ADDENDUM NO. 1

DEERFIELD
Federal Aid Project No. BFL(BR-OFF)-0032(052)X
Bridge Replacement, D-06-001,
Upper Road Over Deerfield River

Transmitting revisions to the Contract Documents as follows:

Revised Plan Sheets 47, 49, 50, 51, 52, 61 & 63 of 92.

- AFTER PILE DRIVING IS COMPLETE, THE CONTRACTOR SHALL SUBMIT PILE DRIVING LOGS INCLUDING THE FINAL TIP ELEVATIONS AND THE RESULTS OF ANY DYNAMIC OR STATIC LOAD TESTING. SIGNIFICANT DEVIATIONS SHALL BE NOTED AS REVISIONS ON THE CONSTRUCTION DRAWINGS.

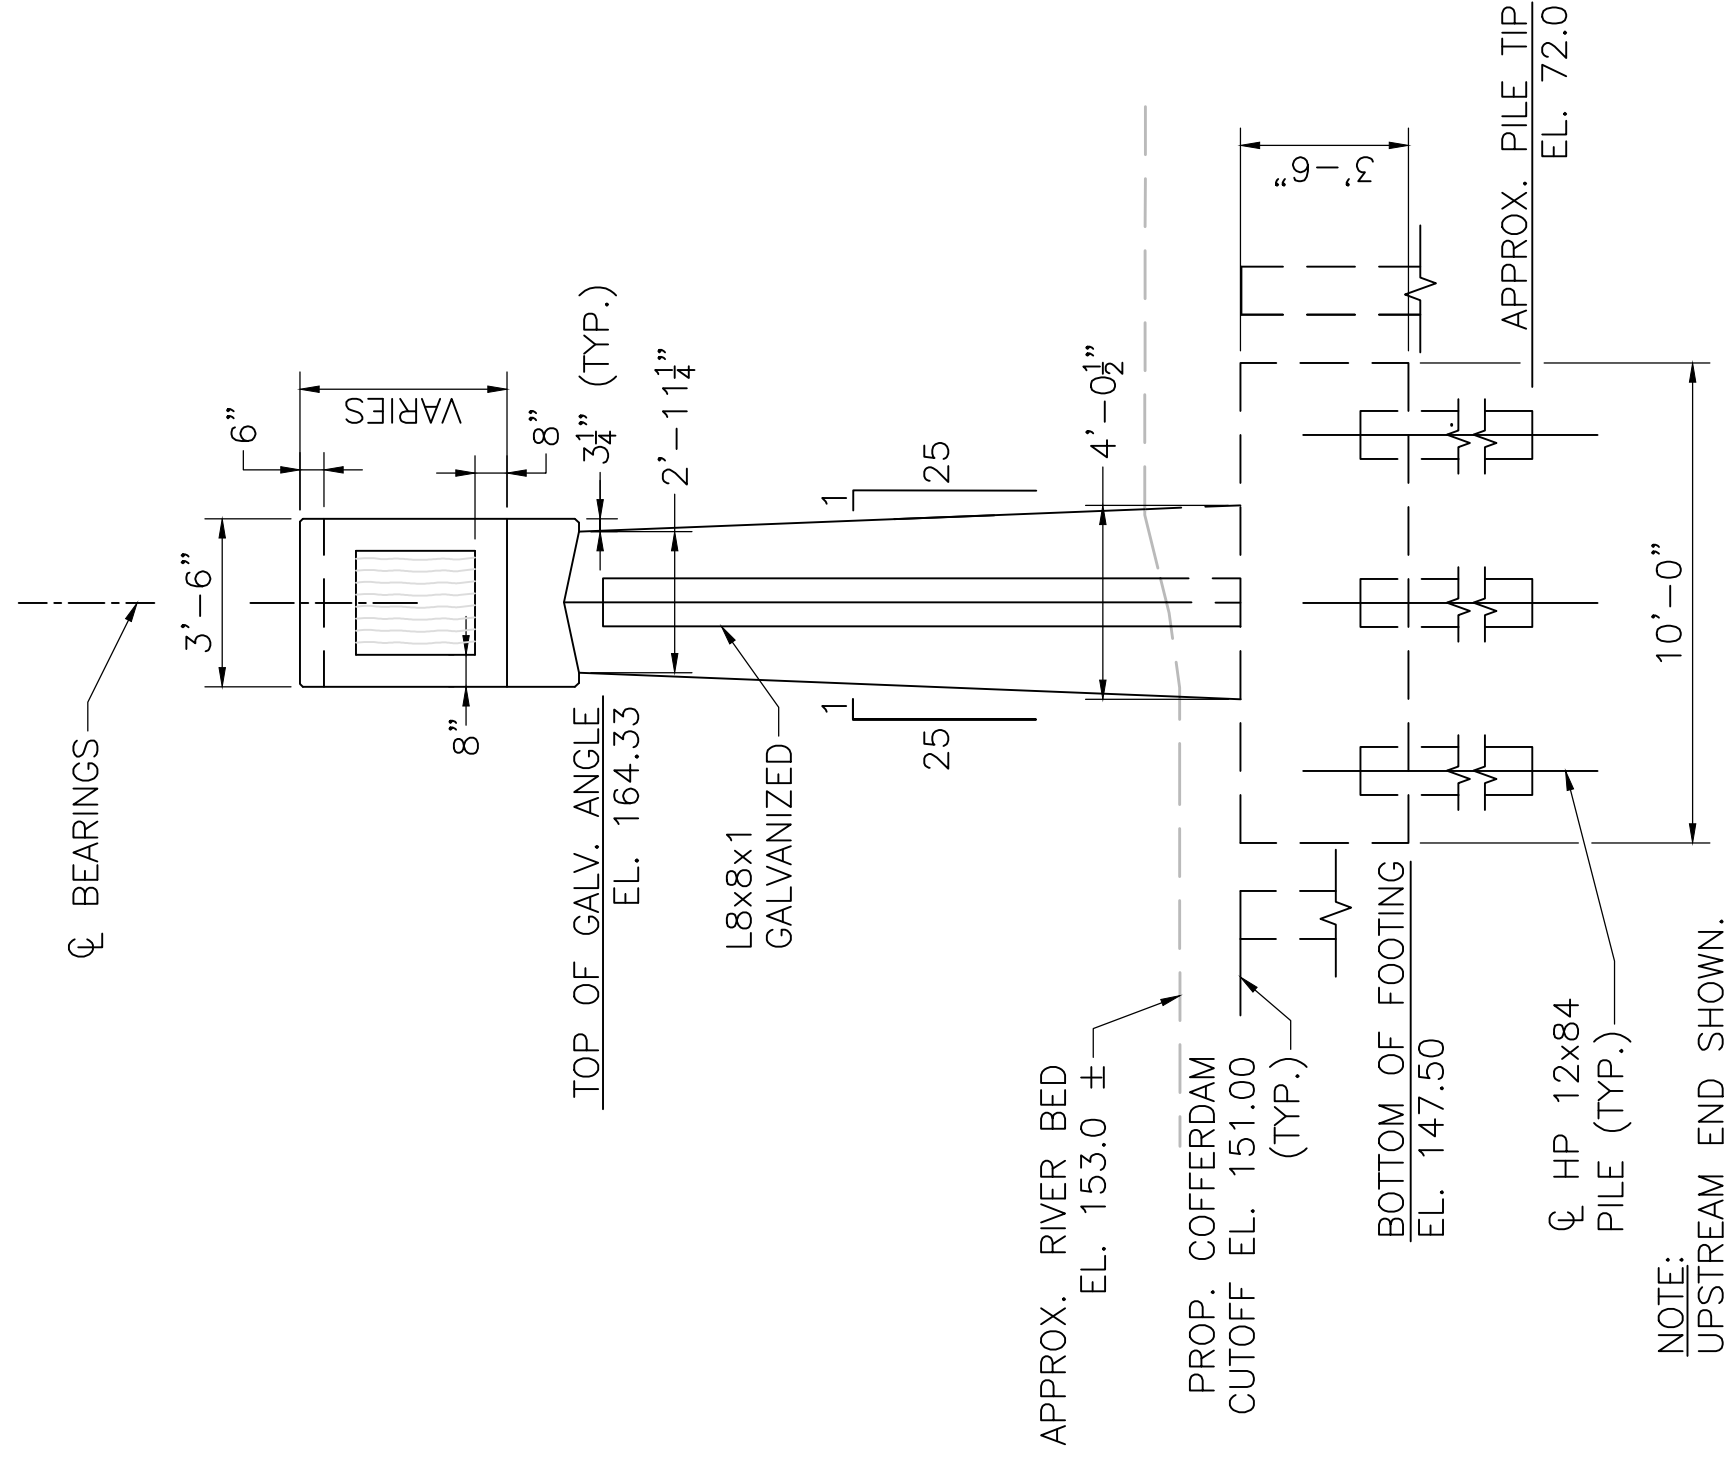
Can Pier 1 be installed and built with construction joints in the footing and stem for the phased construction approach, like what is shown for construction joints in the south abutment?

For pile locations requiring multiple splices due to headroom limitations, please confirm the required pile driving criteria, including any restrictions on driving spliced piles, maximum allowable hammer energy, splice inspection requirements, and any special procedures necessary to achieve the specified pile capacity.

See revised sheets 47 of 92 (11 of 41), 49 of 92 (13 of 41), 50 of 92 (14 of 41), 52 of 92 (16 of 41), 61 of 92 (25 of 41), and 63 of 92 (27 of 41) issued via this addendum.

- DETERMINATION OF THE DRIVEN PILE RESISTANCE, PILE DRIVING CRITERIA, AND PILE INTEGRITY SHALL BE PERFORMED ON THE FIRST PILE INSTALLED FOR EACH PHASE OF PROPOSED PIER NO. 1 CONSTRUCTION USING DYNAMIC TESTING WITH A RESISTANCE FACTOR OF 0.65. PILES SHALL BE INSTALLED TO ACHIEVE A FACTORED DRIVEN RESISTANCE EQUAL TO OR GREATER THAN THE FACTORED AXIAL DESIGN LOAD NEGLECTING AN ESTIMATED 2.14 KIPS OF SIDE RESISTANCE THAT WILL BE LOST DUE TO 5.00 FEET OF DESIGN SCOUR.

- ALL PILE SPLICES SHALL BE EITHER BUTT JOINTS MADE USING COMPLETE JOINT PENETRATION WELDS OR MECHANICAL TYPE SPLICES INSTALLED IN ACCORDANCE WITH THE APPROVED INSTALLATION NOTES. ALL SPLICE WELDS WITHIN 37.5 FEET FROM PROPOSED PIER 1 SHALL BE 100% INSPECTED USING UT.

June 26, 2026	STAGE 1 LIMIT ALTERED
May 30, 2026	ISSUED FOR CONSTRUCTION
DATE	DESCRIPTION
THIS SHEET IS APPROVED FOR CONSTRUCTION BY MASSDOT AUTHORIZED SIGNATORY: _____	
STATE BRIDGE ENGINEER	
USE ONLY PRINTS OF LATEST DATE
